Docket No. 50-416  
LICENSEE: System Energy Resources, Inc. (SERI)  
FACILITY: Grand Gulf Nuclear Station, Unit 1  
SUBJECT: SUMMARY OF FEBRUARY 11, 1987 MEETING  
REGARDING CONTAINMENT PURGING

NRC - SERI MEETING: CONTAINMENT PURGE  
BETHESDA, MARYLAND  
FEBRUARY 11, 1987

"Simplified Composite Drawing of the Containment Ventilation and Filtration System"

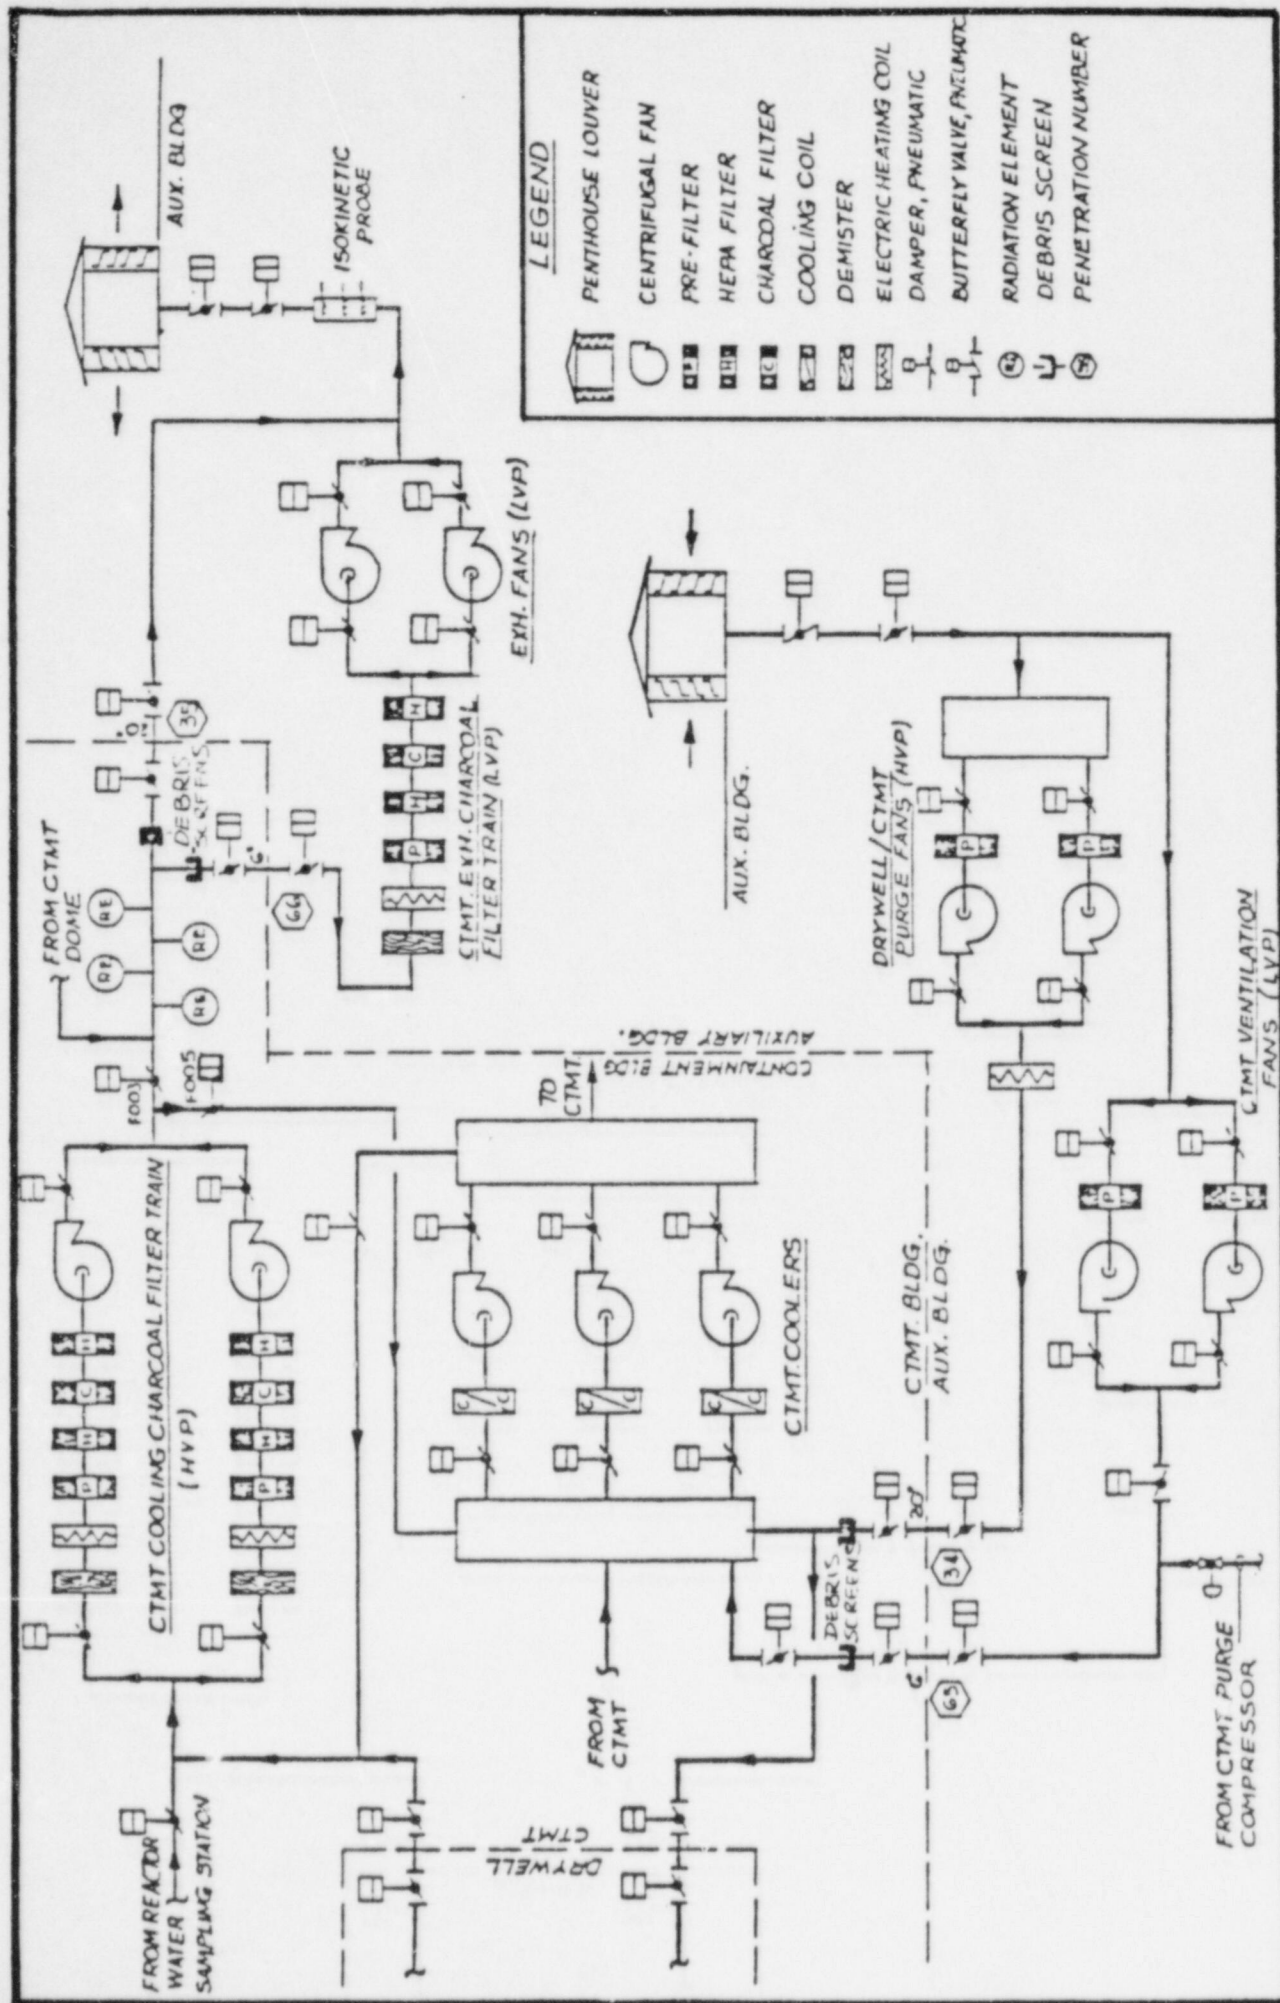
Based on its review of the report, the staff expressed two concerns: (1) that the purge system should not be used for temperature and humidity control; and (2) that the data provided in the report was not adequate to justify the present purge limits. The information presented in this meeting was in response to these concerns.

- NOT RELIED ON TO CONTROL TEMPERATURE AND HUMIDITY.
  - PROVISIONS FOR ATMOSPHERE CLEANUP ARE PROVIDED BY THE CONTAINMENT FILTRATION SUBSYSTEM.
  - ISOLATION FUNCTION IS DEMONSTRATED ONCE PER 18 MONTHS AND LEAK RATE TESTED ONCE PER 92 DAYS.
